GEORGE HALL MPR AND SUPPORT ROOMS PROJECT #19-143

ADDENDUM NO. 2

Date: November 19, 2021

Project: #19-143 George Hall MPR and Support Rooms Project
DSA #: 01-119574 41-26

FLOOR PLAN

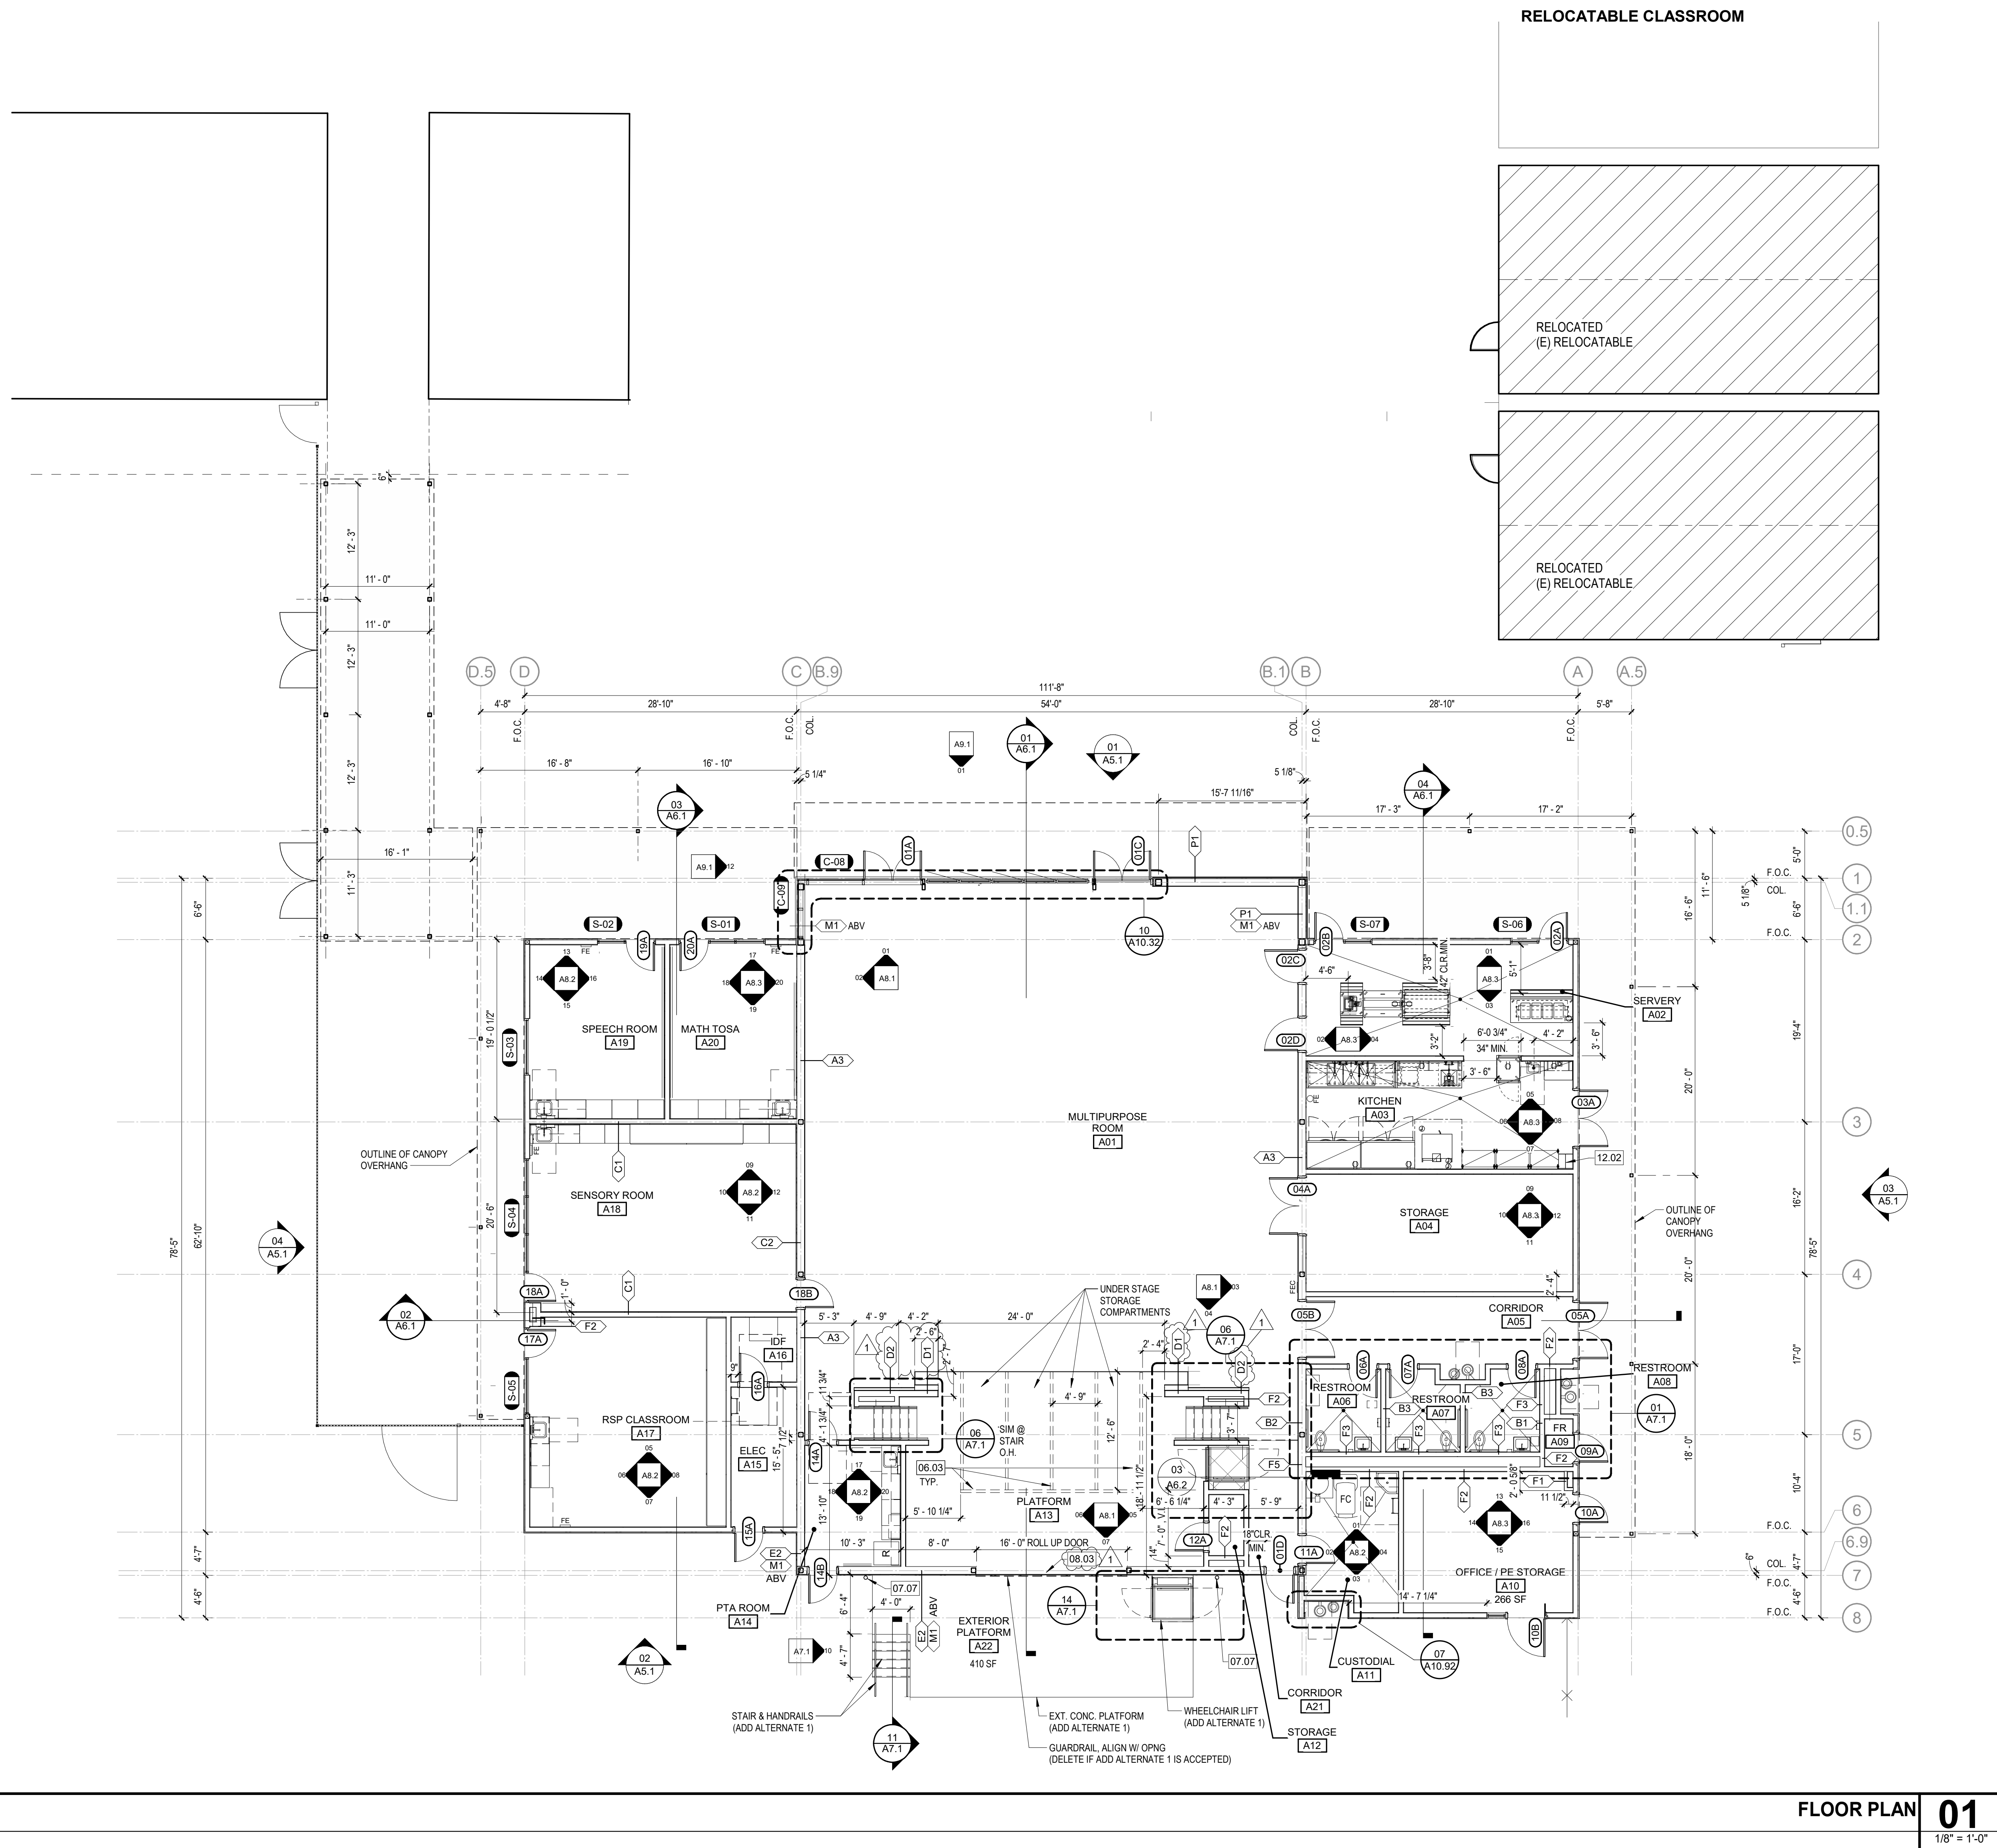
9. SHEET 'A2.1- FLOOR PLAN'
The following drawing is hereby re issued with this following change:
A. Added Keynote '08.03 OVERHEAD ROLL UP DOR, INSULATED, PAINTED W/
RAL COLOR FROM SUCTOM COLOR SHART TO BEST MATCH EP4' on Plan and

Sheet Border.
B. Changed partition types callouts at Proscenium wall.

SHEET NAME:
EXTERIOR ELEVATIONS

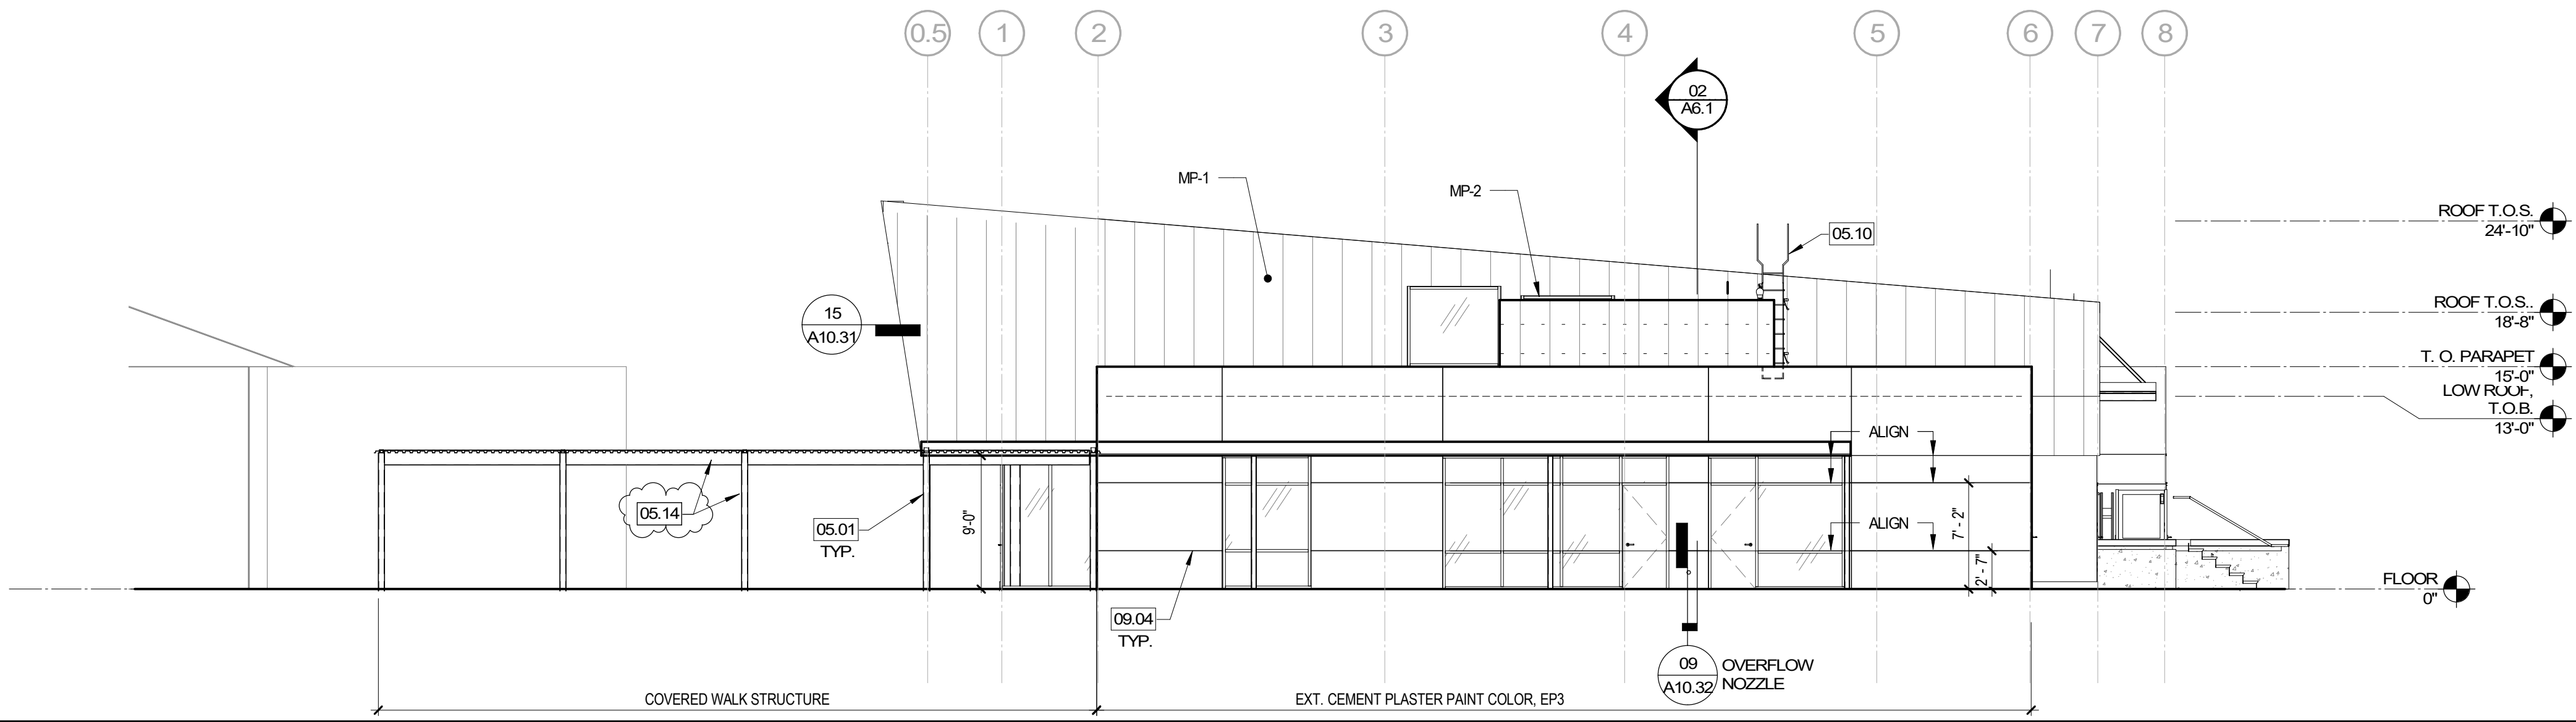
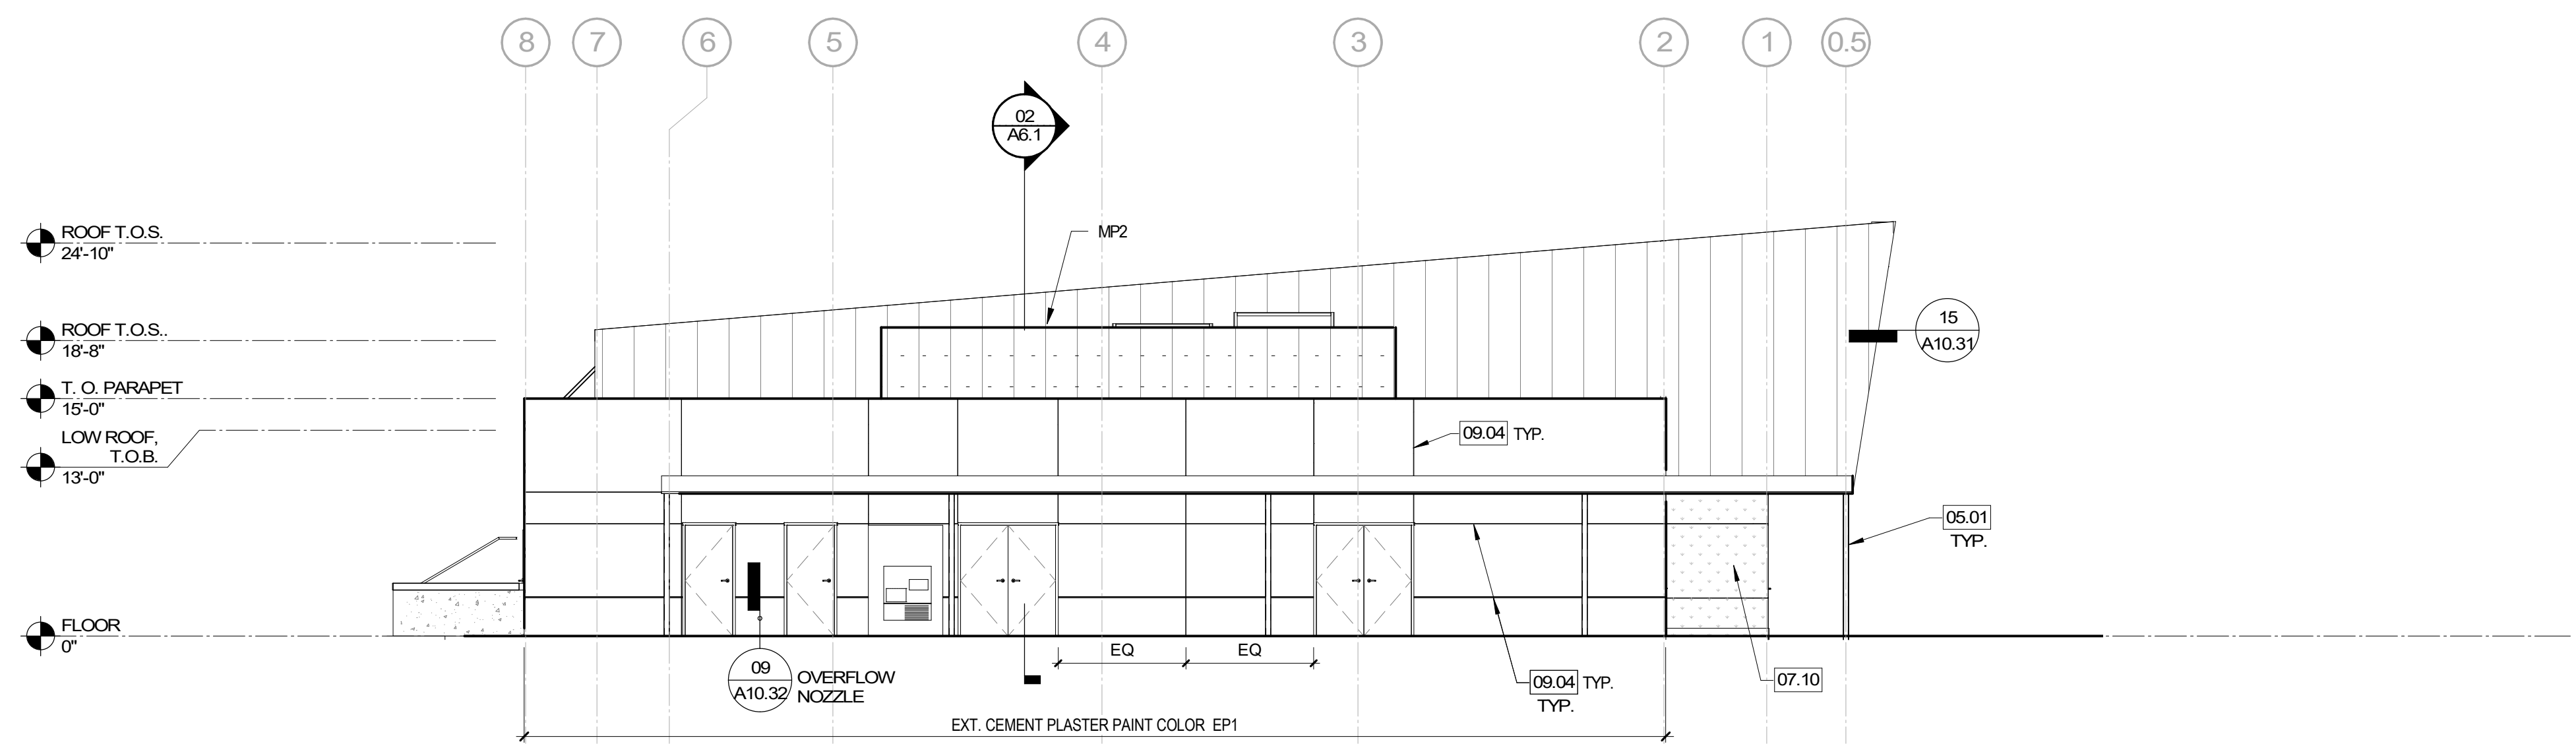
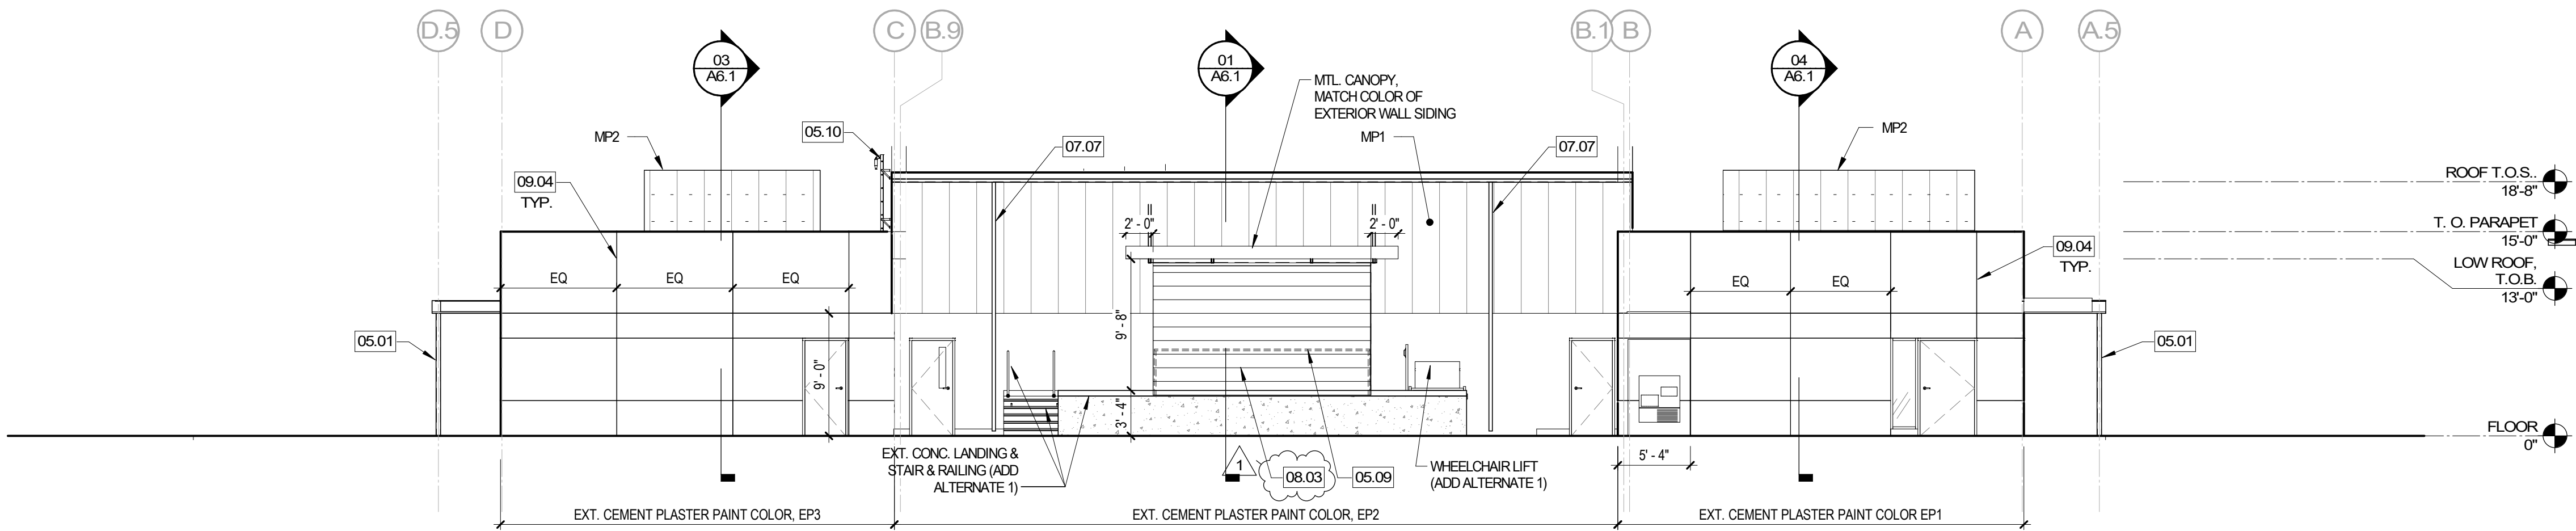
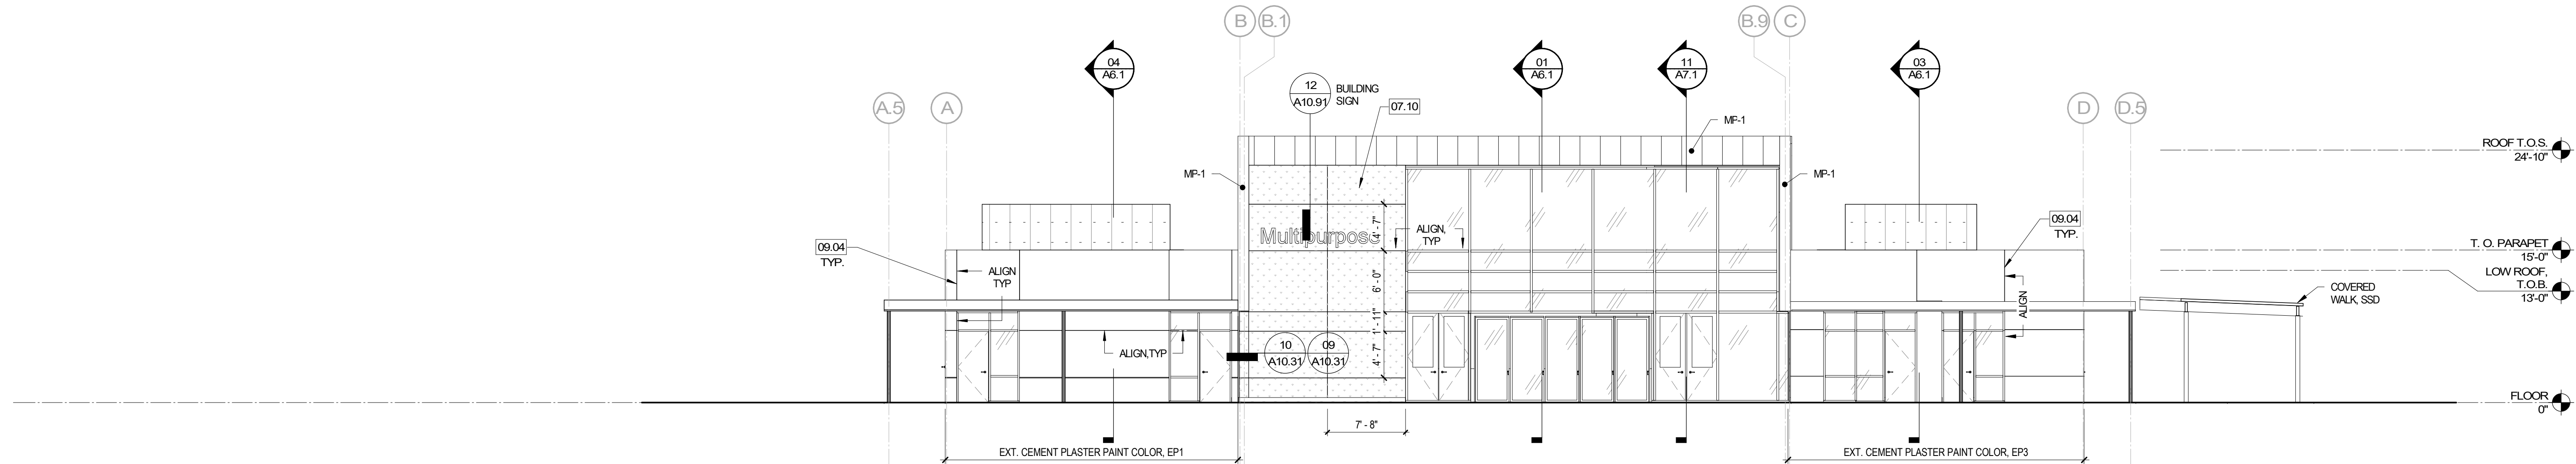
A. Added paint info on Keynote 05.01.

B. Added Roll up door Keynote 08.03.
